**MINISTRY OF BUSINESS,
INNOVATION & EMPLOYMENT**
HIKINA WHAKATUTUKI

Consultation Document

**To update referenced standards and make minor amendments in
the Acceptable Solutions and Verification Methods**

Published 16 August 2013 by
Ministry of Business, Innovation and Employment
PO Box 10-729
Wellington 6143
New Zealand

FIGURE 3.1(B) WIND REGIONS

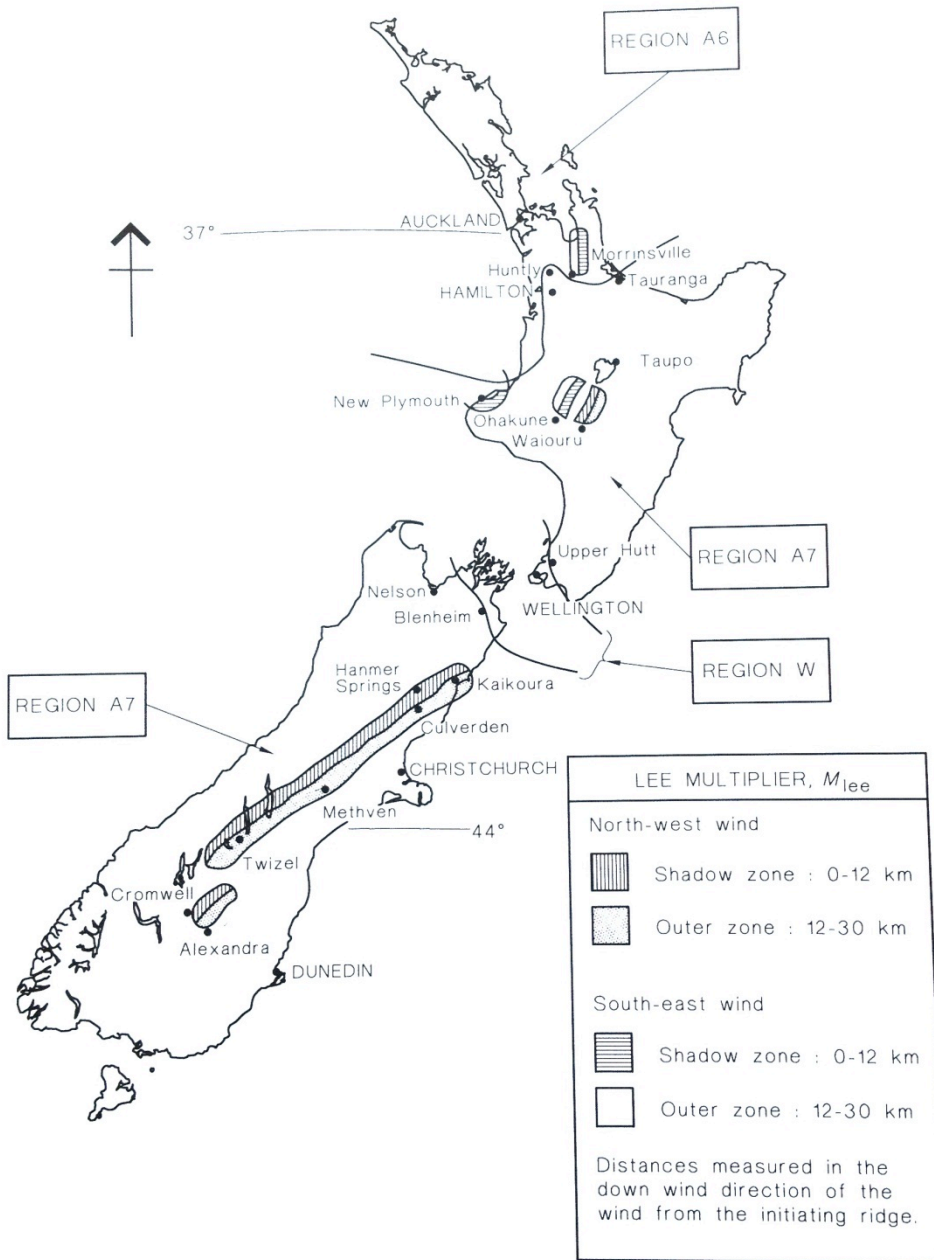
<p>2.2.11 AS/NZS 1170 Part 2, Clause 4.3.1</p> <p>General: Add the following to the end of Clause 4.3.1:</p> <p>“Account must be taken of combinations of isolated tall buildings placed together that lead to local and overall increases in wind.”</p>	<p>2.2.11 AS/NZS 1170 Part 2 Figure 3.1 (B)</p> <p>Delete Figure 3.1 (B) Wind regions and replace with the alternative Figure 3.1(B) Wind Regions below.</p> <p>Comment: There is currently some debate about the applicability of the lee zones in Amendment 1 of AS/NZS 1170.2: 2011. Until it has been established that these lee zones are appropriate and they are verified the wind regions in the un-amended version of AS/NZS 1170.2: 2011 form part of the Verification Methods.</p> <p>Explanation: Existing paragraph 2.2.11 is deleted because it is now included in the standard. A new 2.2.11 paragraph referencing Figure 3.1 (below) has been added.</p>
